**NuLu**  
**Review Overlay District**  
Report of the Urban Design Administrator to  
the Committee

**Case No:** 17COA1108  
**Classification:** Non-Expedited

**Property Address:** 900, 906, 914 E. Main Street

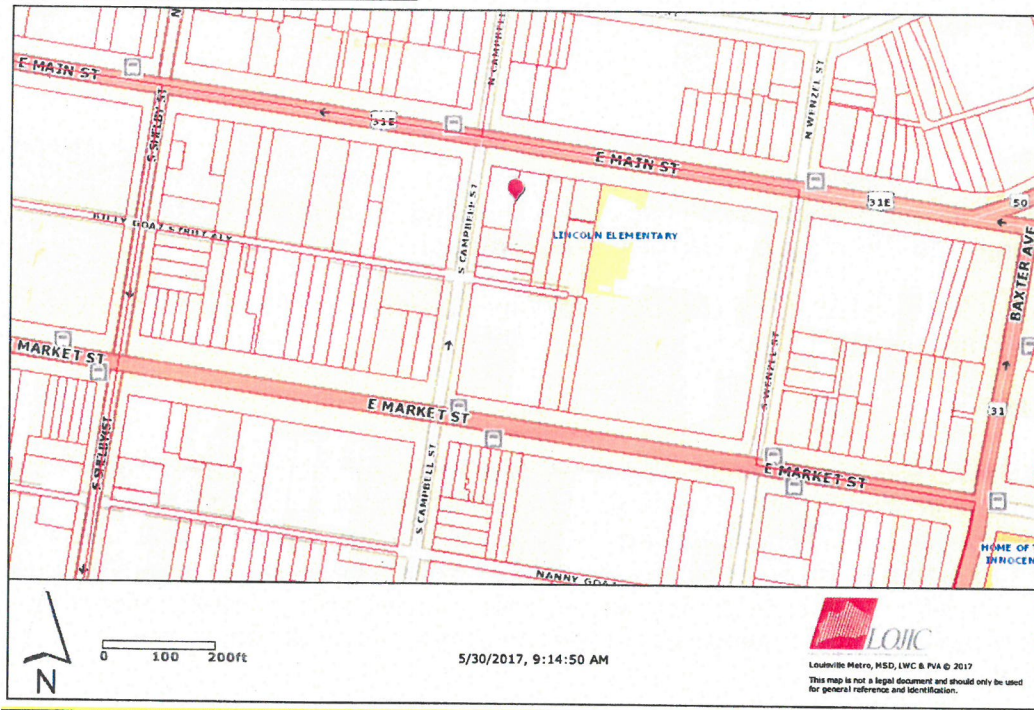
Along the **North Façade**, the exterior masonry will be scraped of existing paint and be repainted. The existing storefront along East Main Street will be restored; wooden storefront system is to be replaced. Existing downspout, soffit, and gutter systems will be replaced. A new roof deck and elevator shaft will be installed. The existing signs will be painted over.

A painted sign with the words "DeHart Paint Company" is situated between the second and third floor, and is one of the building's three (3) contributing signs to the district (See **Principle 1- Signage**). The sign will be painted over.

|           | Guideline                                                                                                                                                                                                                                                                                                                                                                                                                                                                                                                                                                             | Finding | Comment                                                                                                                                                                                                                                                                                                                                |
|-----------|---------------------------------------------------------------------------------------------------------------------------------------------------------------------------------------------------------------------------------------------------------------------------------------------------------------------------------------------------------------------------------------------------------------------------------------------------------------------------------------------------------------------------------------------------------------------------------------|---------|----------------------------------------------------------------------------------------------------------------------------------------------------------------------------------------------------------------------------------------------------------------------------------------------------------------------------------------|
| <b>S1</b> | Applicants are required to re-use and reface existing "significant, historic, or contributing signs". "Significant, historic, or contributing Signs" are signs that are unique in design or material fabrication. These signs contribute to the history and diverse character of the NuLu Review Overlay District. (See list of significant, historic, or contributing Signs; below table). For signage to be recognized as "significant, historic, or contributing" or for existing recognized signs to be removed or altered an application must be submitted to the overlay staff. | +/-     | Existing contributing signs on this site are highlighted below; applicant is not proposing to reuse sign. the existing signs are included in the paint finish over the entire building. The paint surface is failing and is proposed to be removed and repainted anew. This will result in the loss of the painted signage by default. |
| <b>S2</b> | Significant, historic, or contributing signs or graphics that have been painted directly onto walls and represent out of date logos or logos for businesses that are no longer in business are encouraged to remain in either their existing faded condition or restored to their original condition. These signs are recognized as contributing to the historic artistic character of the area and our community.                                                                                                                                                                    | +/-     | See comment above. The painted signs are part of a paint surface that is failing and in general disrepair and to be completely repainted.                                                                                                                                                                                              |

1. Applicant is encouraged to explore options to retain, reproduce, or otherwise reference some portion of the existing Contributing Signage in the new exterior finish plan of the building.
2. Final signage plans to be submitted once tenants are established for review and approval in accordance with Signage Guidelines
3. Final outdoor lighting plans to be submitted for review and approval
